SIB 11 09 21

2022-05-27

RECALL 21V-907: EXHAUST GAS RECIRCULATION (EGR) COOLER – N47T HIGH TEMPERATURE

This Service Information Bulletin (Revision 2) replaces SI B11 09 21 **dated February 2022**.

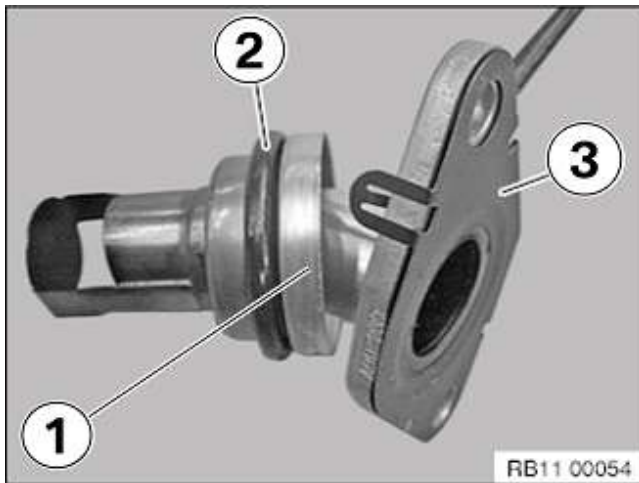
- When the old EGR cooler is removed:

- Remove the EGR pipe from the intake venturi pipe (replace O-ring (2) and gasket (3)).

- Inspect and clean (if needed) the EGR pipe. Wear protective equipment (eyes and hands) and clean out the excessive carbon using a degreasing agent and a brush (suitable brushes can be found in wheel brush kit 83 19 2 298 237).
- Reinstall the EGR pipe with new gasket and O-ring before installing the new EGR cooler.
- Install the new EGR cooler following the repair instructions.
